September 12, 2025

2262 78th Ave SE Critical Area Study Peer Review

Facet Project No: 2410.0634.04

Figure 1. Mapped stormwater conveyance and open watercourse (source: Mercer Island GIS Portal)

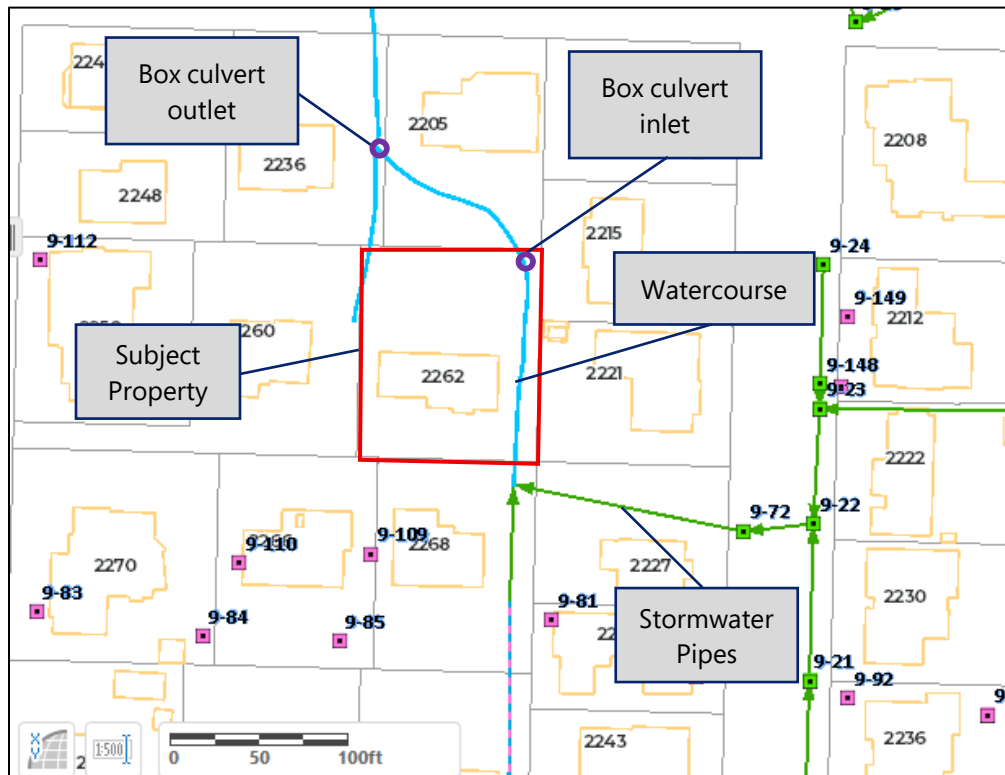
City GIS-based mapping inventories are somewhat ambiguous as to whether the on-site ditch is a watercourse or a stormwater conveyance feature. The available mapping shows the transition from a piped storm main to an open watercourse near the subject parcel's southern property boundary (Figure 1). However, based on field observations, there is no discernable distinction between the characteristics of the feature at this location (Figure 3). The ditched feature is situated on a relatively flat terrace flowing north before entering a vertical concrete box culvert at the northern property boundary (Figure 4). The culvert's mapped discharge location is near the top of a natural ravine, the point at which the CAS identified the start of the regulated watercourse.

Figure 6. LIDAR-based topographic image, subject property in white (source: King County iMap)

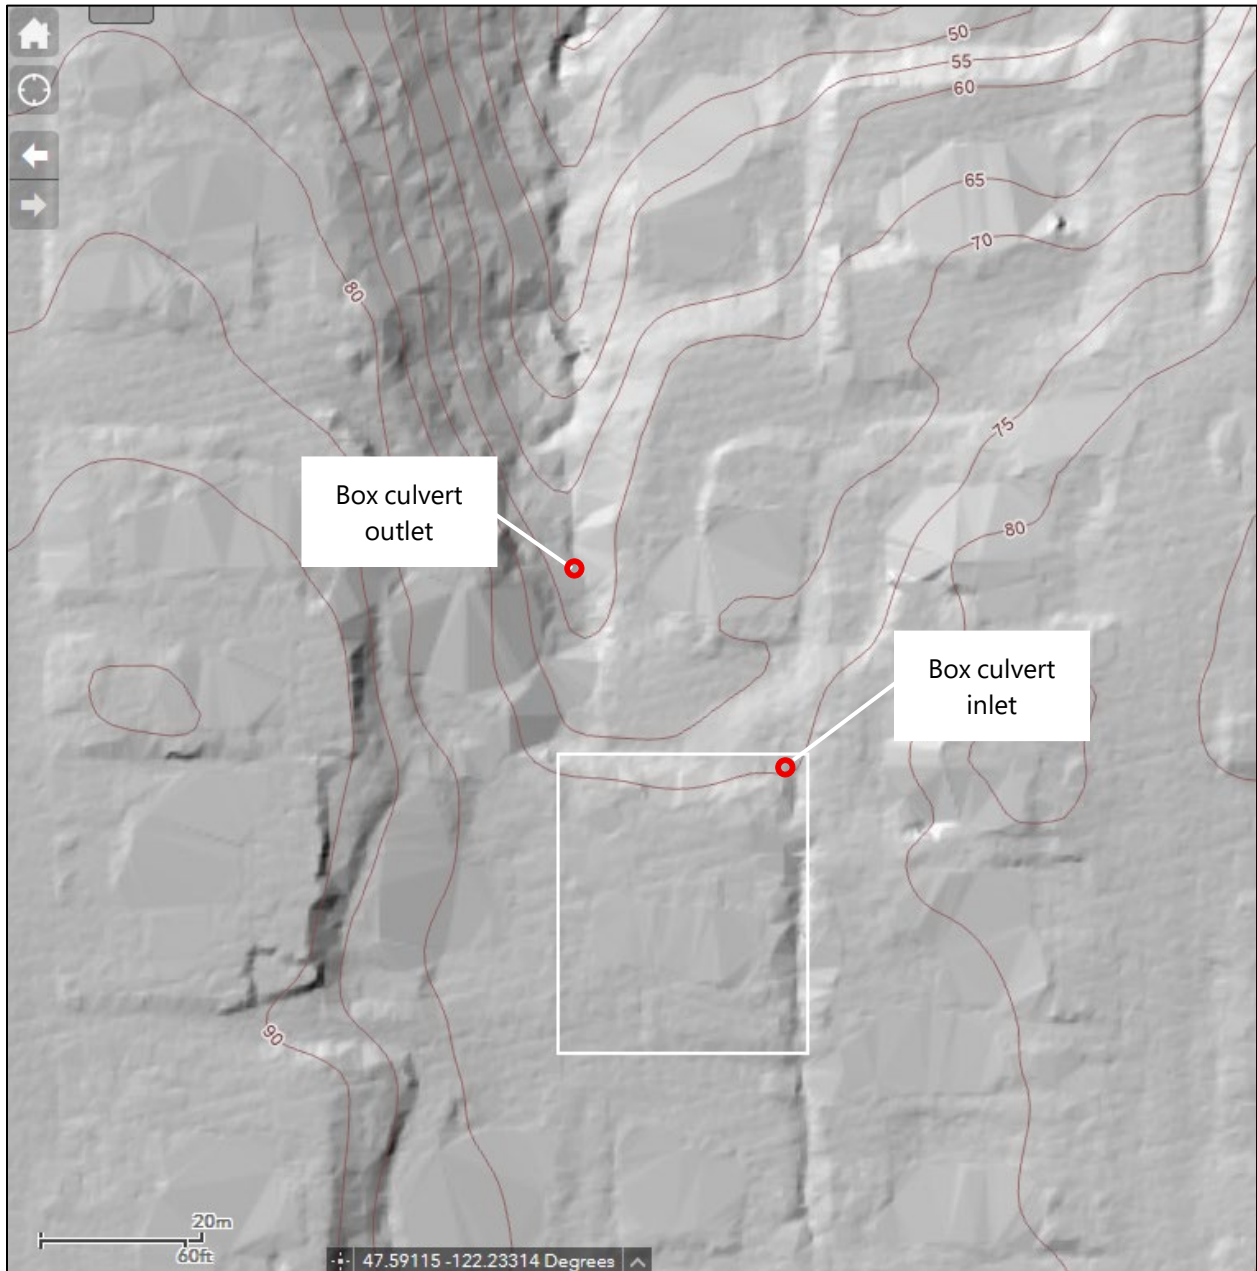
To determine if the on-site portions of the open channel are part of a modified, natural stream channel or an entirely artificial stormwater conveyance system, I reviewed historic aerial imagery, all available public inventories, and LIDAR-based topographic imagery and mapping. A review of historic aerial photographs, particularly from 1936 (when vegetative cover was absent), suggests that there was no stream channel present in this location at that time (Figure 5). Mercer Island GIS mapping (Figure 1), visual observations (Figures 2 and 3), and LIDAR-based topographic images (Figure 6) suggest that the on-site channel is an excavated feature (steep, vertical sides and linear orientation). The landscape position of the subject property, situated atop a relatively flat terrace unassociated with known wetlands or seeps, is not a typical landscape position in which the headwaters of a small stream would be located. Rather, the steep ravine just north of the subject property is more indicative of a topographic feature that would channelize surface flows or groundwater seeps into a defined stream channel. A pronounced change in gradient and channel incision is visible beginning at the location where the concrete box culvert discharges into the ravine (Figure 5). Bed, bank, sorted sediments, and erosion indicators are not present in the short section of the ravine above the discharge. Such characteristics were observed through binoculars beginning at the discharge point. Therefore, based on the preponderance of available data, it is my conclusion that the on-site channel segment is an artificially created stormwater conveyance feature and not a historic watercourse channel that is regulated as a critical area under MICC 19.07.
